Technical Bulletin

Number: 084a
Date Issued: 08/31/12

Subject/Key Words:	150MM Carrier Rod Style Replacement Difference - New Supply Rev. Change			
Classification:	<input checked="" type="checkbox"/> Informational	<input type="checkbox"/> Mandatory	<input type="checkbox"/> Safety Alert	<input type="checkbox"/> PM Impact
	<input type="checkbox"/> Warranty Impact	<input checked="" type="checkbox"/> Purchase Parts	<input type="checkbox"/> No Charge For Parts For _____ Days After Issue Date.	
Parts/Reference Documents:	204759-001 and 204760-001 Carrier Rod Replacement (Annual) and Carrier Frame Replacement (3-Year) on page 2 are reprinted from GAMA PM and System Checks Manual (rev 09/12), pages 14-15.			
Attachments:	None

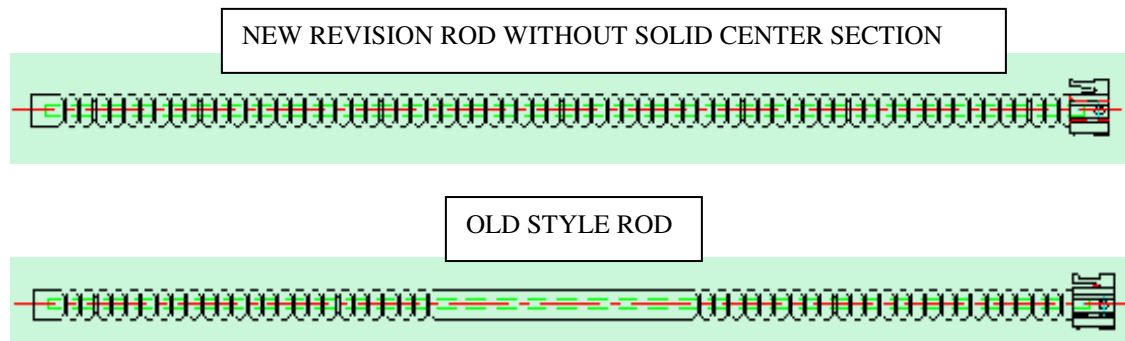
Issue: The solid center section was removed on the 150mm lower rods (See PN's listed above). The new revision lower rods have been profiled the entire length as a design improvement.

Do not be confused by this change in appearance.

- Whenever rods are changed or a carrier is replaced, wafers should be manually inserted into each rod slot to ensure proper wafer vertical positioning.
- A wafer transfer check should be done to ensure transfer combs and carrier/wafers are properly aligned.
- The checks are critical if the timing of your annual PM upper and lower rod replacement does not coincide or if you are installing a new rod to replace one that has been damaged.

Carrier Rod Replacement (Annual)

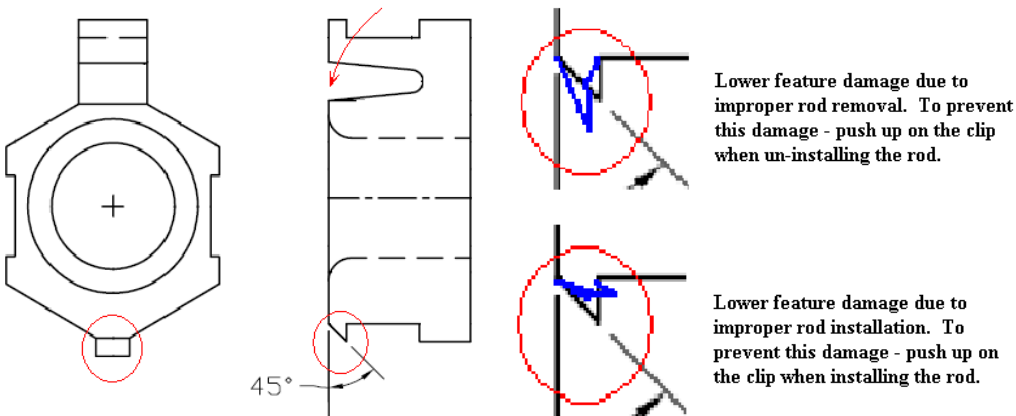
New Rod clip shown undamaged – highlighted areas of concern: lower securing tang and upper spring clip. Once the lower feature is damaged its retaining ability is reduced. Low temperature applications may be tolerant of the diminished feature but high temperature applications are apt to result in rods becoming displaced and subsequent damage to wafers may occur.

Rods with damaged clips should be replaced or refurbished.

To further prevent dislodging rods which may have damaged retaining clips, ensure proper alignment of wafer transfer system lift combs or wafer pushers. Perform several wafer transfers in the WTS to confirm proper alignment and operation. Carrier frames must always be supplied by Akrion Systems to ensure proper dimensional specification tolerances.
